Executive Director's Recommendation

Commission Meeting: February 7, 2013

PROJECT Intelligence and Security Command Expansion – Phase 1 Fort Belvoir, North Post Fairfax County, Virginia	NCPC FILE NUMBER 7450
SUBMITTED BY United States Department of Defense, Department of the Army	NCPC MAP FILE NUMBER 2204.10(38.00)43693
REVIEW AUTHORITY Advisory per 40 U.S.C. § 8722(b)(1)	APPLICANT'S REQUEST Preliminary approval of site and building plans
	PROPOSED ACTION Approve with comments
	ACTION ITEM TYPE Staff Presentation

Figure 11: Rain Garden Detail

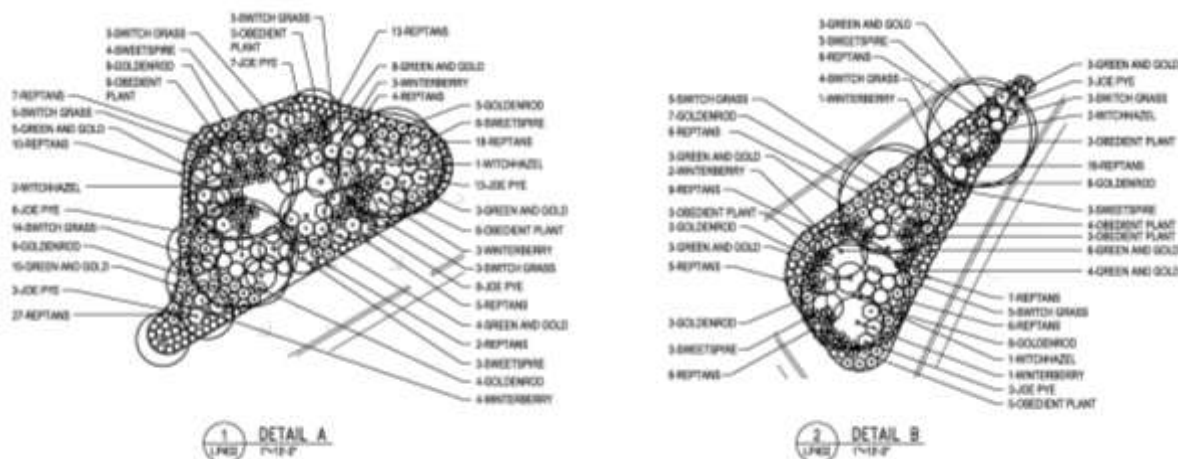
the proposed rain gardens and rainwater harvesting/reuse system. The DPWES provide comments on the materials used in the stormwater management system and we encourage the Army to evaluate the comments as it moves forward with final design of the system.

- Sheet LP500 includes a rain garden detail, which includes filter fabric between the soil and gravel layers. Filter fabric has a high clogging and failure rate in rain gardens and bioretention systems, and it is suggested that the rain garden specifications be modified to remove all filter fabric and replace it with a four-inch layer of pea gravel between the #57 stone and the soil layer.
